State of Idaho
Department of Water Resources
Water Right License

WATER RIGHT NO. 63-32049

MEMORANDUM

SUBJECT: Licensing Review of Water Right 65-32049

By PEC Date 9/10/15 Client BOISE VALLEY FEEDERS Sheet 1 of 1
Chkd By _____ Description 63-32049 BUFE Job No _____

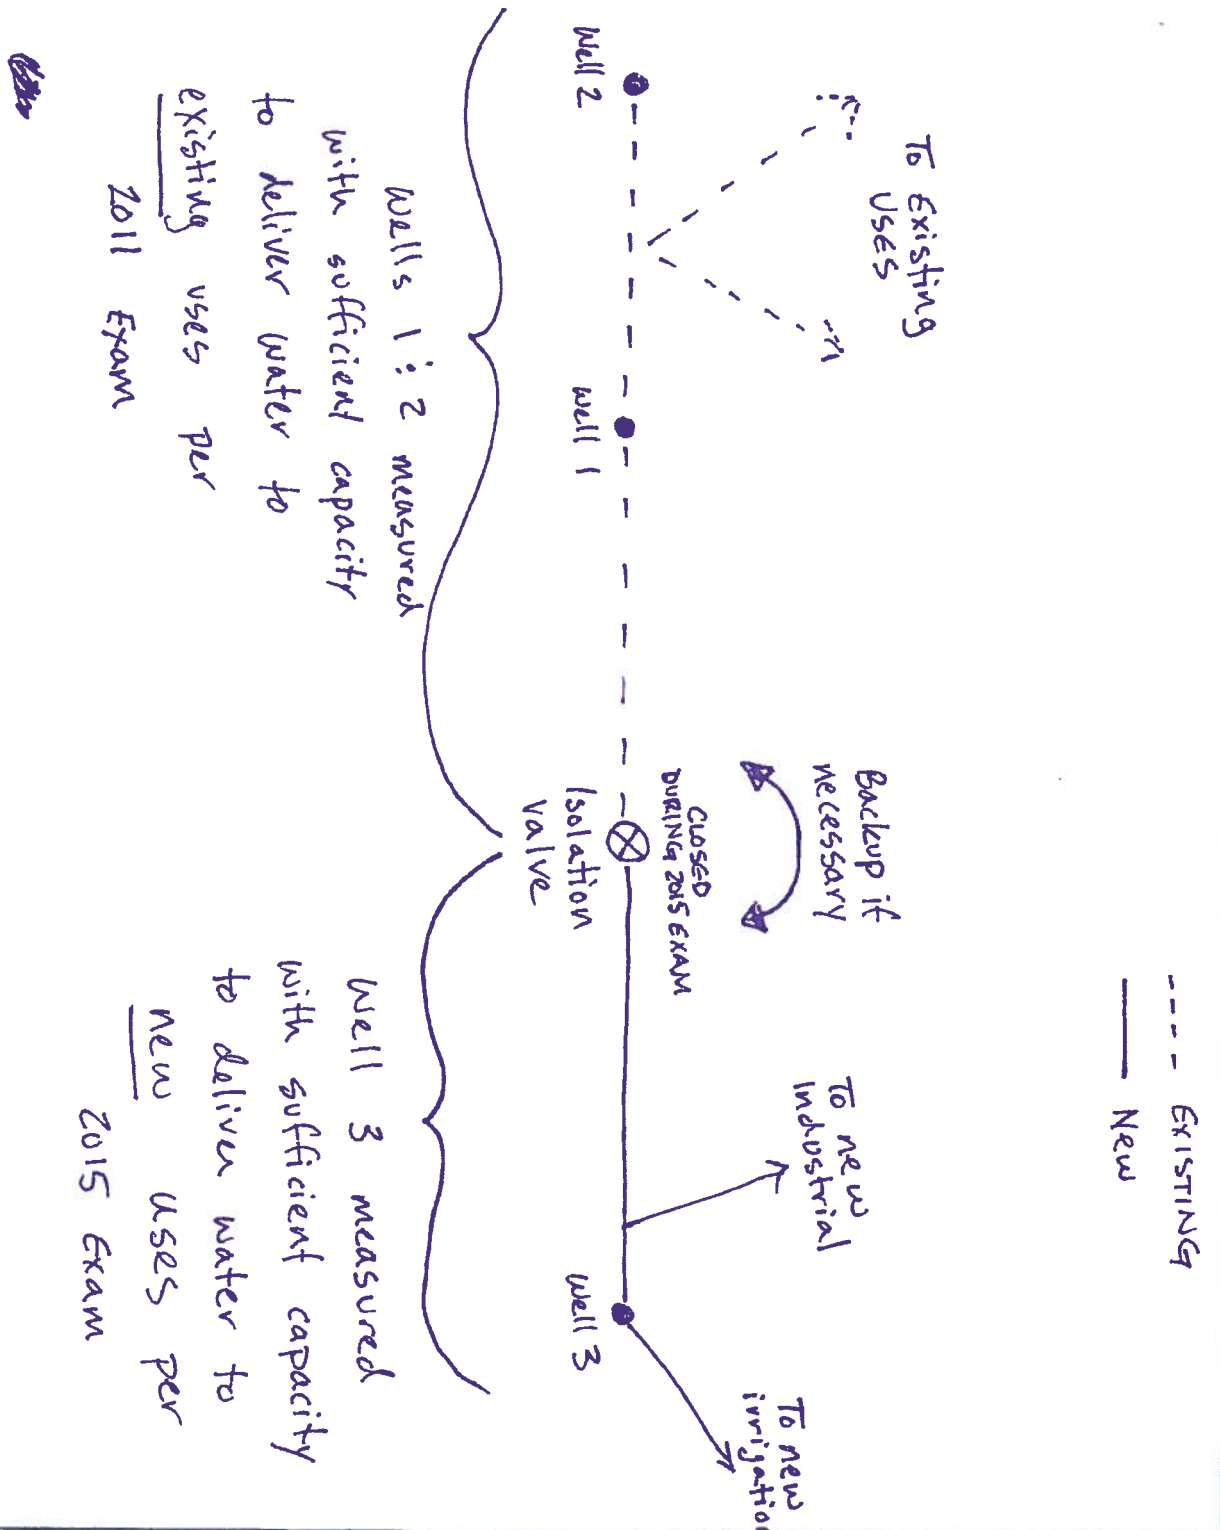
I have attached a very simplified diagram of this system. The areas serviced by Wells 1 and 2 can be completely separated from the new industrial and irrigation areas described in Permit 63-32049 that are serviced by Well 3 by closing the isolation valve, as was the case during my measurement. This is a "normal" operation for Boise Valley Feeders as they tend to run the Well 3 irrigation and industrial system at a slightly higher pressure than the Well 1 and 2 system. As described in my exam, well 3 alone has sufficient capacity to meet the new irrigation and industrial uses which were isolated from the Well 1 and 2 system during the measurement by closing the isolation valve. Similarly, Wells 1 and 2 have enough capacity to fully supply the existing uses that were similarly isolated from the well 3 system during the measurement by closing the isolation valve. The new uses do not need capacity from wells 1 and 2, and the existing uses do not need capacity from the new well 3. However, any of the wells could act as a backup to each other in times of need.

Photo Map

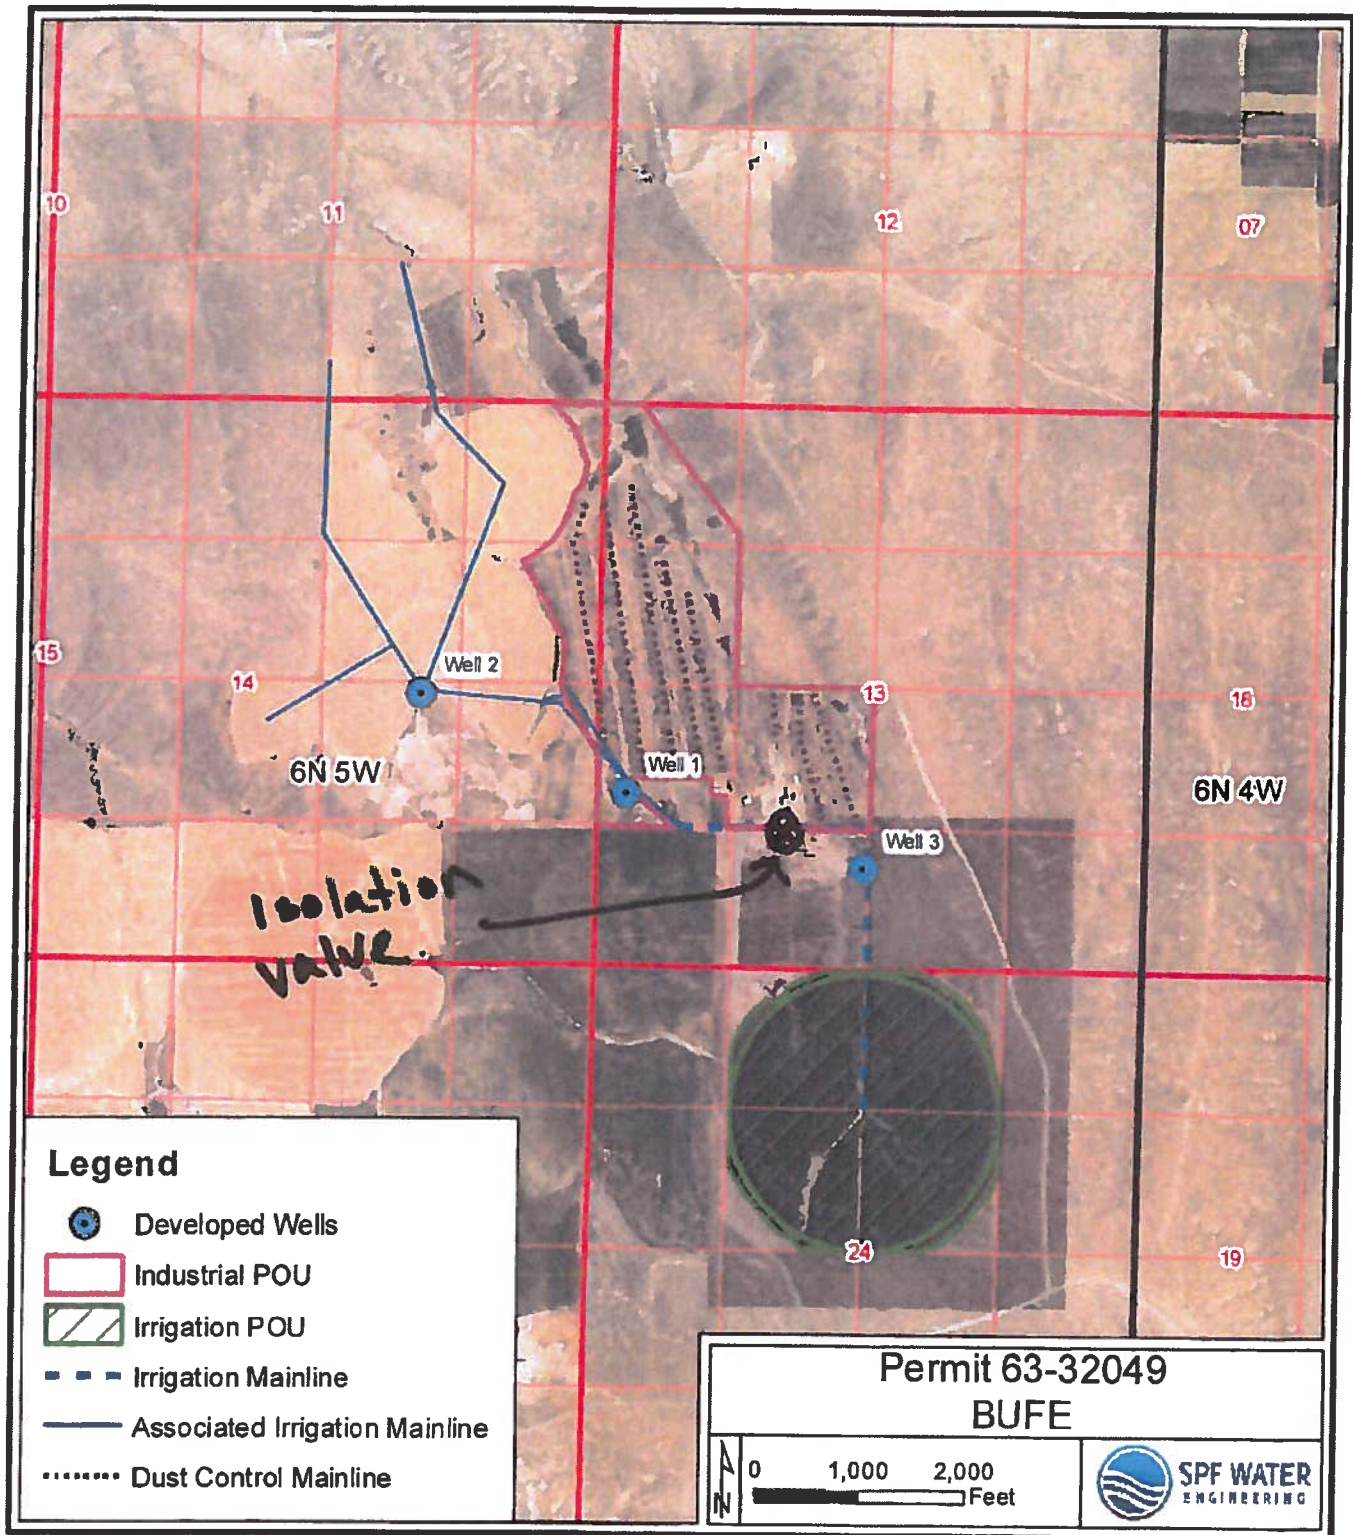
2. Page 3 of the attached pdf shows the photo map that was included with my exam for 63-32049. I have drawn in the isolation valve that was closed during my measurement of Well 3, something I probably should have included originally. With this isolation valve closed, Well 3 was completely isolated from Wells 1 and 2 during my measurement. Because this isolation valve was closed during my measurement of Well 3, Wells 1 and 2 could have been set up to run exactly as they did during Mr. Scanlan's 63-31262 exam back in 2011 (in which the 5.68 cfs measurement was completed) at the same time that my measurement of 3.82 cfs was completed on Well 3. I am still having a very difficult time understanding why another measurement would be required with the valve open. This valve allows redundancy in the system so that if for some reason well 3 were to go down, Well 1 and 2 could be used to back feed the well 3 area, or similarly if Well 1 or 2 were to go down, Well 3 can be used to deliver water to those areas. That is why those points of diversion were included on this permit. However, it is a normal operation for this valve to be closed so that the well 3 area can be ran at a higher pressure. Well 3 alone has sufficient capacity to meet the irrigation and industrial uses developed under permit 63-32049, so capacity from Wells 1 and 2 is not needed across the isolation valve for full appropriation of the permitted flow rate.
